<b>Report to</b>	Norwich Highways Agency Committee 24 November 2011	<b>Item</b>
<b>Report of</b>	Head of city development	<b>9</b>
<b>Subject</b>	Duke Street contra-flow cycle lane

To consider objections to the proposal for introducing a contra-flow cycle lane on Duke Street from Colegate to St Andrews Street

### PROPOSED CONTRA-FLOW CYCLE LANE FOR DUKE STREET, NORWICH

#### RESULTS OF PUBLIC CONSULTATION, OCTOBER 2011

<table><tr> <th>Date</th> <th>Scale(s)</th> <th>No.</th> <th>Date</th> <th>Notes</th> <th>REVISIONS</th> <th>Int. Clkd.</th> </tr><tr> <td colspan="2">DWG. No. 10 HM 046 1/4</td> <td></td> <td></td> <td></td> <td></td> <td></td> </tr></table>

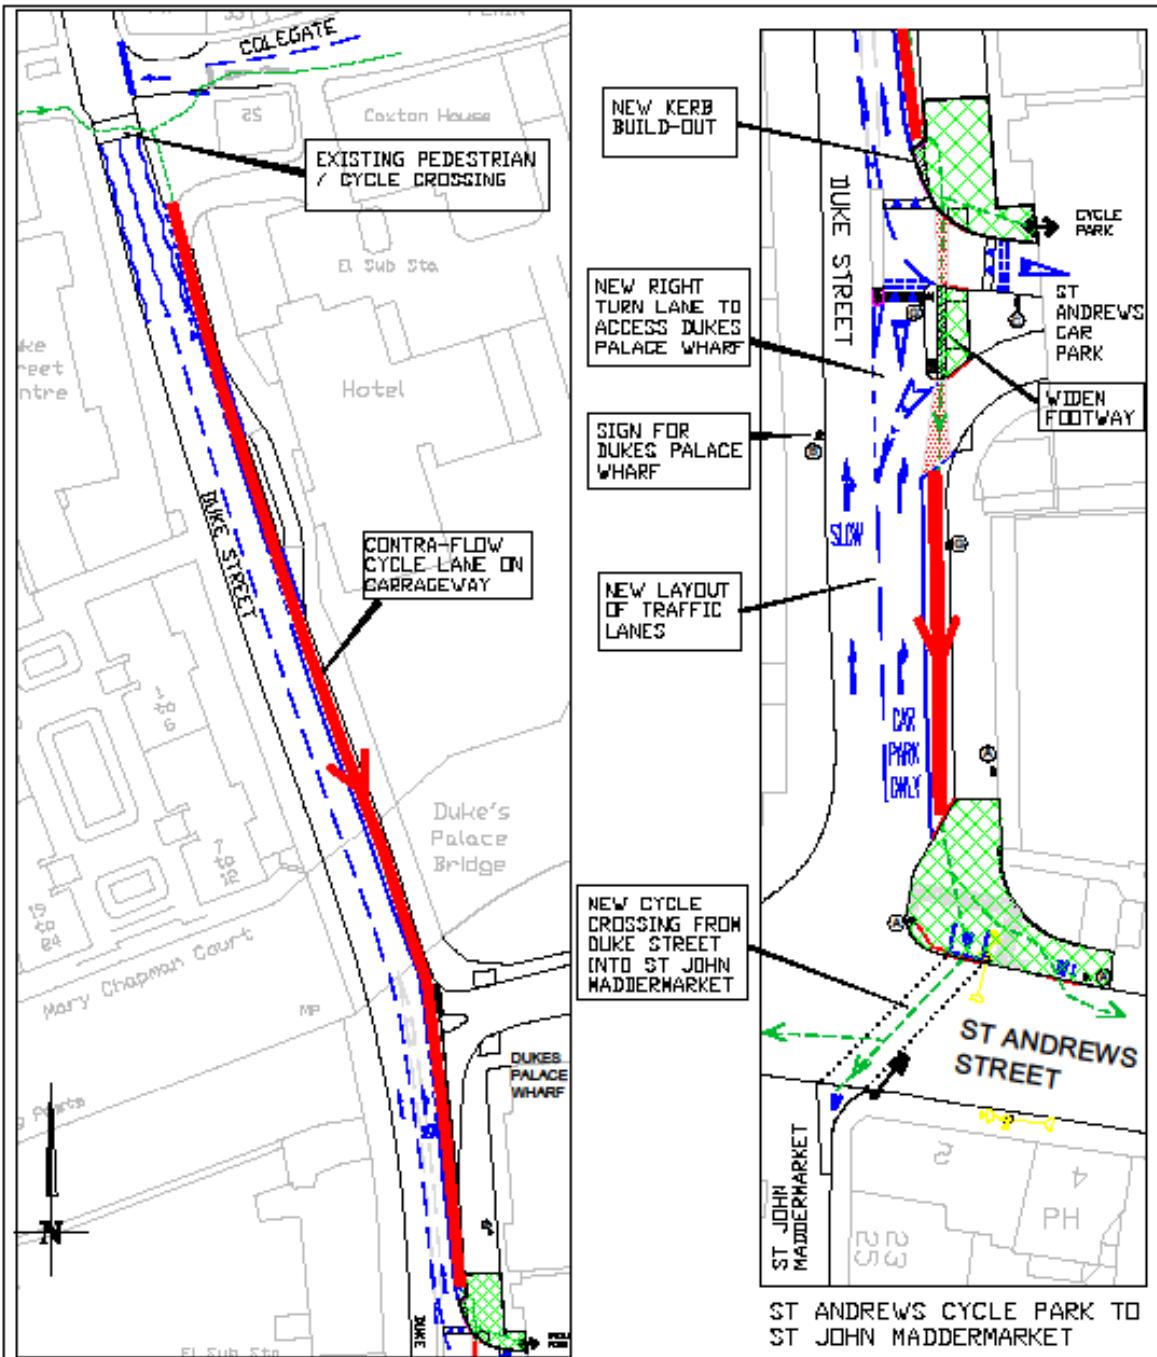
ADDRESS	SUMMARY OF OBJECTION / COMMENTS	OFFICERS' RESPONSE
Duke Street (exact address not given)	<p><b>OBJECTION</b> 1. Northbound traffic will not have a clear view of on-coming cyclists due to the rise in Duke Street caused by the bridge. 2. Cyclists will be in conflict with traffic entering and leaving the Premier Inn, Dukes Palace Wharf and St Andrews Car Park. 3. The shared use area on St Andrews Street is heavily used by pedestrians. 4. The proposal is unsafe and expensive to implement. 5. It would be better to convert the west footway to shared use.</p>	<p>1. The bridge does not create a significant visibility problem. Also, through traffic heading north will be on the west side as it passes the car park, and cyclists will be in the cycle lane on the east side, with the car park exit lane separating them. There should not be any risk of them coming into contact before the bridge. 2. Warning signs will be provided at these exists. 3. Shared use areas have worked successfully elsewhere. 4. The scheme has been audited by Safety Engineers. 5. The west footway was looked at for shared use but there were concerns about the Arts college and also the height of the parapet of the bridge</p>

20 Dukes Palace Wharf	<p><b>OBJECTION</b> 1. A 2m cycle lane will narrow down the traffic lanes, and parking outside Mary Chapman Court will need to be banned. 2. The areas of shared use are heavily used by pedestrians. It would be safer to make the west footway into shared use. 3. Cars and vans often park in the area outside the cycle park entrance, and in the access road to Duke Palace Wharf. This will make the problems worse. 3. The 2m width lane may not be wide enough to allow 2 cyclists to pass in opposite direction. 4. With a give way line at the car park exit, who has right of way? 5. It would be cheaper to mark out a cycle lane on the west footway.</p>	<p>1. There are 2 northbound traffic lanes, so it should not be necessary to ban parking / loading outside Mary Chapman Court. 2. The west footway was looked at for shared use but there were concerns about the Arts college and also the height of the parapet of the bridge. 3. Illegal parking is an enforcement issue. 4. The contra-flow cycle lane is for southbound cyclists only. Northbound cyclists should use the northbound traffic lanes. 4. The give way will raise awareness of cyclists and encourage car drivers to give way. 5. See 2 above.</p>

48 Dukes palace Wharf	<p><b>OBJECTION</b> - The cycle route should be on the west footway. <u>Comments</u> - Cars exit the car park at speed, cyclists exiting riverside walk may be a problem for traffic exiting Dukes Palace wharf, vehicles using the slip road to access Duke's palace Wharf will tail back into Duke Street causing congestion</p>	<p>The west footway was looked at for shared use but there were concerns about the Arts college and also the height of the parapet of the bridge.</p>

Norwich Hackney Trade Association	<b>OBJECTION</b> - This scheme will encourage more cyclists to use the section of Duke Street from the roundabout to Colegate as an unofficial contra-flow cycle lane, which will be very dangerous.	The feasibility of providing a southbound cycle route along this section may be looked at in the future if funding permits. There is a proposal to remove the sub-way on St Crispins Road and install a pedestrian ctycle crossing near the St George Street junction, which would provide an alternative for cyclist.
Exposure Cameras, Colegate	<u>Comments</u> - 1. Concerned that if the St Andrews Cycle park is made more popular, it will need to be enlarged at the expense of spaces for cars. 2. The exit to St Andrews Car Park will become more dangerous as cyclists don't currently give way to vehicles. 3. Cyclists should be able to use the west footway.	1. There are currently no proposals to extend the cycle park. 2. Cars exiting the car park will be warned of the cycle crossing and required to give way to them. 3. The west footway was looked at for shared use but there were concerns about the Arts college and also the height of the parapet of the bridge

50 Duke's Palace Wharf	<u>Comments</u> - 1. Concerned about safety around the car park exit with cyclists crossing. 2. Some vehicles have been seen driving southbound along Duke Street. 3. It would be safer if cyclists were able to use the west footway.	1. Cars exiting the car park will be warned of the cycle crossing and required to give way to them. 2. Noted. 3. The west footway was looked at for shared use but there were concerns about the Arts college and also the height of the parapet of the bridge
Norwich Cycle Campaign	In favour of the proposals	Noted
